DREW AND MARYLOU SUBDIVISION 1229 AND 1219 AYRSHIRE ST.

SUMMARY

PROPOSED PLAT

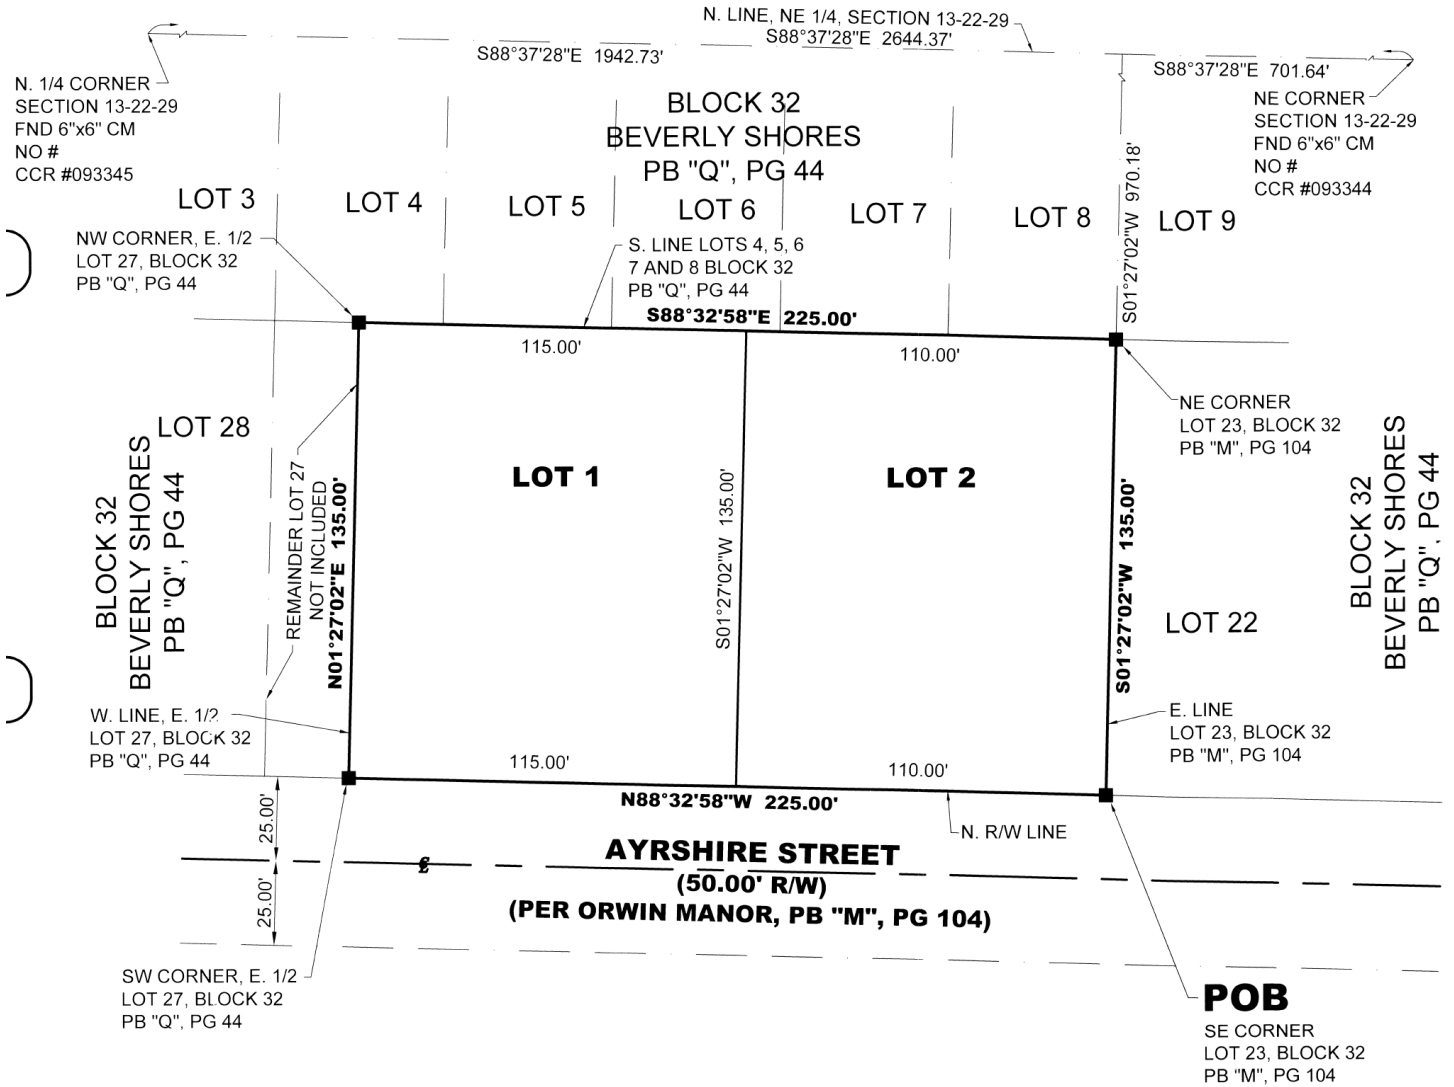
10. Plat Face Changes - There are a number of changes required to the face of the plat. In addition to the changes required on the plat, the following is a list of additional requirements. 1) Changes to the face of the plat. (A copy has already been returned to the surveyor). 2) Recording Fees (Checks should be made payable Orange County Comptroller.) 3) The plat must be reviewed by Orange County prior to recording. Begin this process by taking a copy of the executed plat to Room 1700 (Orange County Property Appraiser's Office, Attn. Rocco Campanale), 200 S. Orange Avenue, Sun Trust Bank Center. The original completed Statement of Lien from Orange County is required by this office. The Statement of Lien must be received by this office prior to recording the plat.
